URBAN DESIGN REVIEW & PRELODGEEMENT PANEL ADVICE

PROPERTY: Lot 117 Lachlan's Line (6 Halifax Street, Macquarie Park)

PRELODGEEMENT No: PRL NO: PRL2023/0006

DEVELOPMENT: **Proposed Affordable housing development. 9,887sqm of GFA including 13 storeys 38 car parking spaces and total 135 units**

Figure 2: Markup of Elevation (Base Source: SJB Architects)

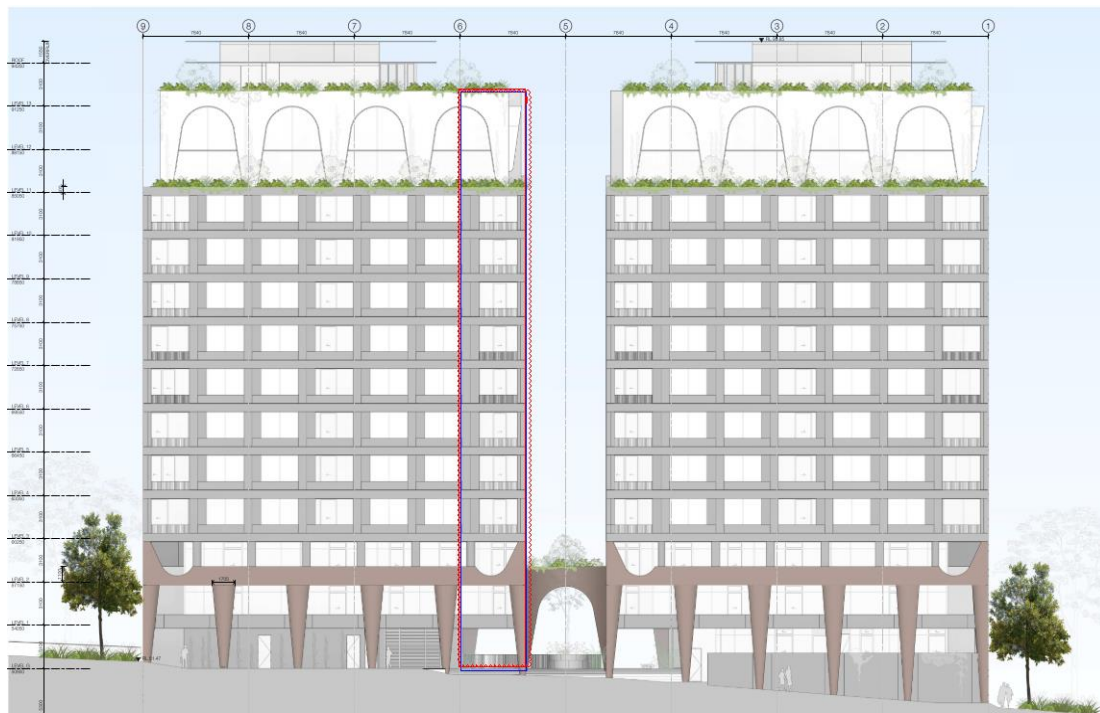
Buildings A and B are physically separated by approximately 6m on levels 1 to 10; on levels 11 to 12, the building separation increases to approximately 6.6m to 8.5m. This is an issue where habitable rooms and balconies will be overlooking each other.

The Applicant should investigate a more slender and taller towers by cutting some GFA from the edges and taking the lost GFA to new additional upper floors. Currently the scheme proposes a building height of 43.4m height against permitted height of 75m.

Figure 2 shows that 24 units taken away from one of the towers (red clouded area in figure 2– this can be split to both towers) that can be accommodated within two additional floors, increasing the height to approximately 49.6m. This will create much better and compliant building separation, better amenity from acoustic, cross ventilation and solar access perspective.

This design change will need to be tested from an overshadowing perspective on Linear Park.

On submission of a DA additional testing on built form massing and overshadowing impacts should be provided for Linear Park.

Figure 3: Extract showing proposed rezoning (Source: House Keeping Planning Proposal)

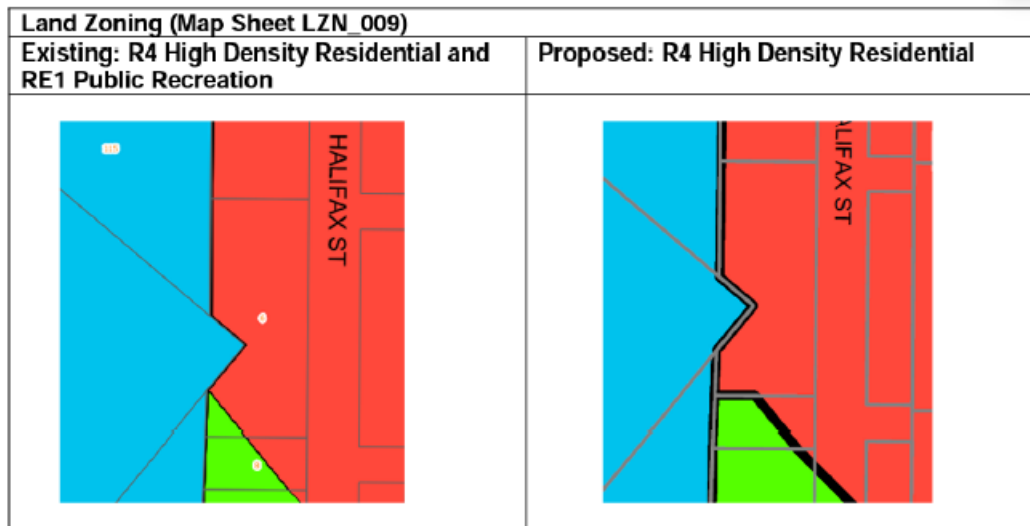
Under the *Ryde Local Environmental Plan 2014* (RLEP), the site has a split zoning of R4 High Density Residential and RE1 Public Recreation. The development proposed is a permissible purpose with development consent under the RLEP however parts of the development encroach into the RE1 zoned land, therefore being partially prohibited.

The proposal in its current form is prohibited under the existing land zoning controls under the Ryde LEP 2014, as some balconies protrude into the area zoned RE1 Public Recreation. However, there is a current Housekeeping Review Planning Proposal (PP-2022-1043) at the finalisation stage with the Department of Planning and Environment (DPE) to amend the RE1 land zoning to R4 (Figure 3 and link here):

Figure 8: Flood Risk Precinct Extract (Source: Ryde Maps)

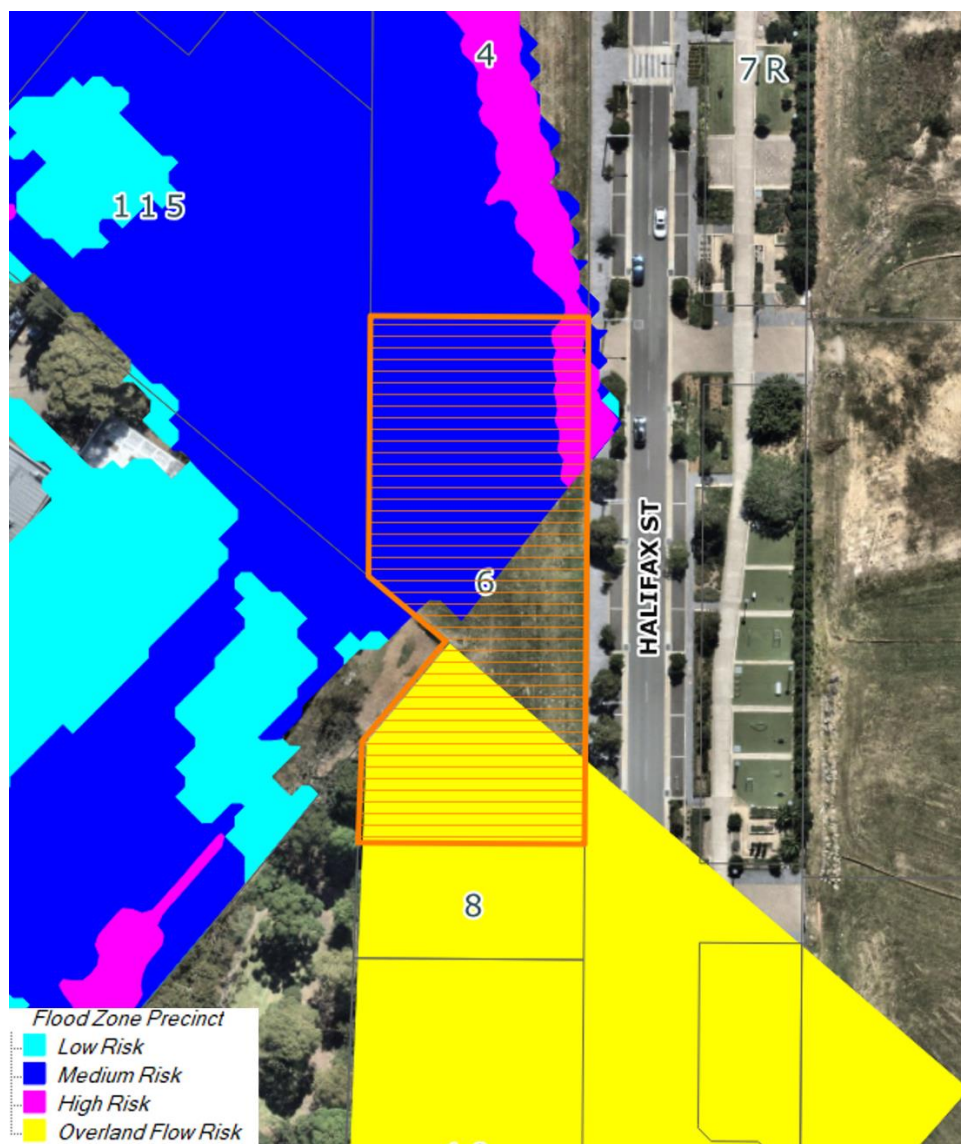
- The site is affected by an overland flow path (Figure 8). Flood Impact Assessment Report must be prepared for pre and post developed scenario using 2D flood modelling software. The applicant shall prove that the proposed development is not adversely affecting the flood conditions to the neighbouring properties or downstream catchment. This includes 1% AEP and PMF Velocity Depth product (VxD), Flood Hazard Vulnerability, Flood Velocity and Flood Level values.

Figure 10: Area of proposed easement encroachment

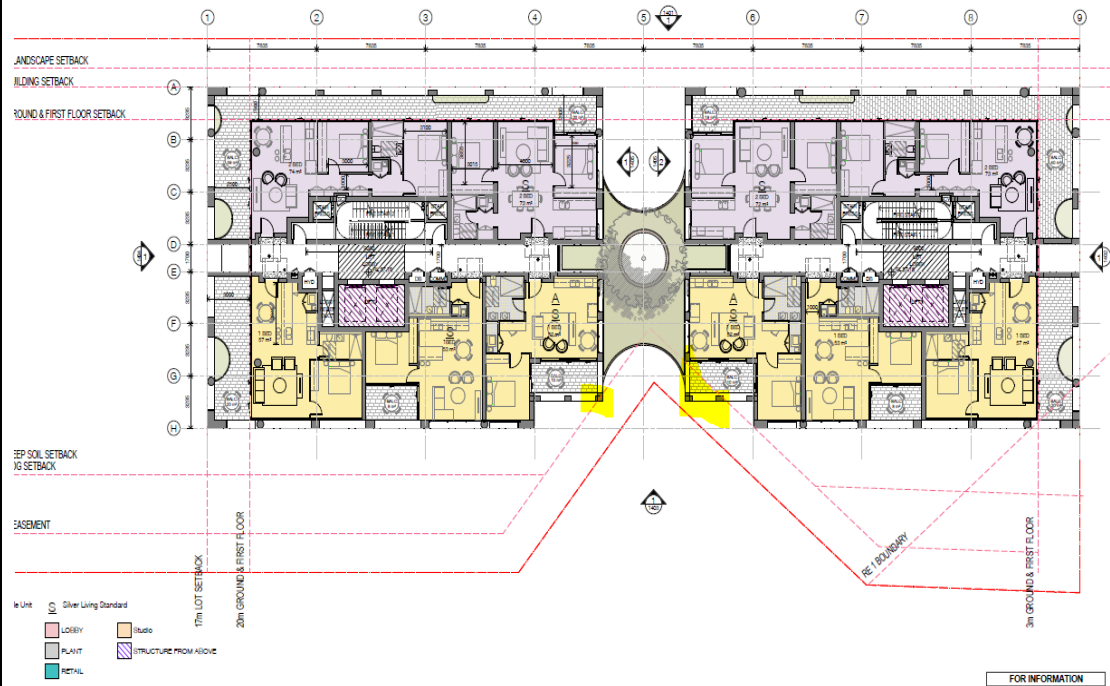
- It appears that the proposed development is encroached into the drainage easement. Please note that any encroachment to the easement must be avoided. Please see Figure 10.

Figure 11: Markup of Basement Plan

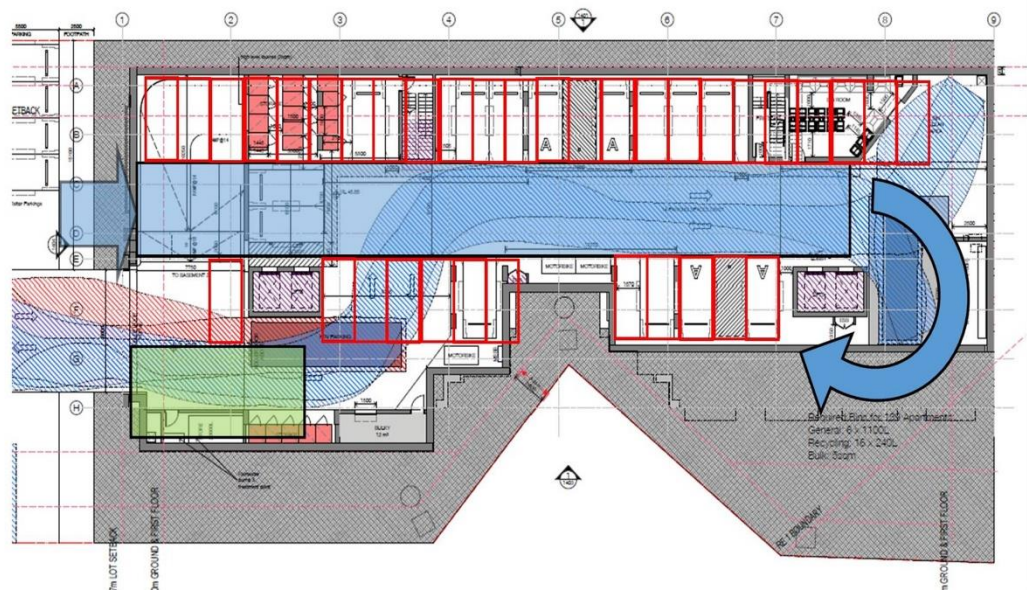
- There are considerable fundamental issues with the arrangement of the service bays in the development. The positioning of the HRV loading bay in the access aisle is unacceptable as it will impose on vehicle movements, present a significant traffic safety issue due to obscured sight distance in the service area to through traffic and pedestrians plus it will require the vehicle to reverse out of the facility with very limited visibility to approaching traffic. The loading bay positioned at the far eastern end of the basement parking area is also of great concern as there would appear to be inadequate manoeuvring clearance being provided in this location. Notably a portion of the swept path is through a corner of the lift shaft, no clearances appear to be provided from the surrounding structure and the design still requires a vehicle to perform a multipoint turn to exit. The applicant is also to note that the Council's waste vehicle dimensions are longer than a MRV vehicle and will therefore have greater swept path which will exacerbate the matter.

- The configuration of the internal ramp having right angle corners down to the lower level presents a poor design outcome for a new development as it does not reflect the circular path of a vehicle, is not compliant with AS 2890.1 in terms of minimum ramp radii and the configuration effectively presents as a one way ramp being unable to accommodate opposing traffic flow.

- The loading bay area could be relocated to the southern (lowest) side of the development footprint, towards the end of the Mews Road driveway. Having the loading bay accommodated in the development footprint and enable Mews Road to be utilised as a manoeuvring area.
- The garage entry for vehicles could be located further uphill of the Mews Road ramp.
- The ramp to the lower level could circulate around a lift shaft at the eastern end.
- The basement level be extended under Mews Road to expand parking capacity, noting that a right-of-way (required for access to the development to the northwest) could be defined in stratum.
- **Note this VERY conceptual plan below and should be tested by the Applicant (Figure 11);**
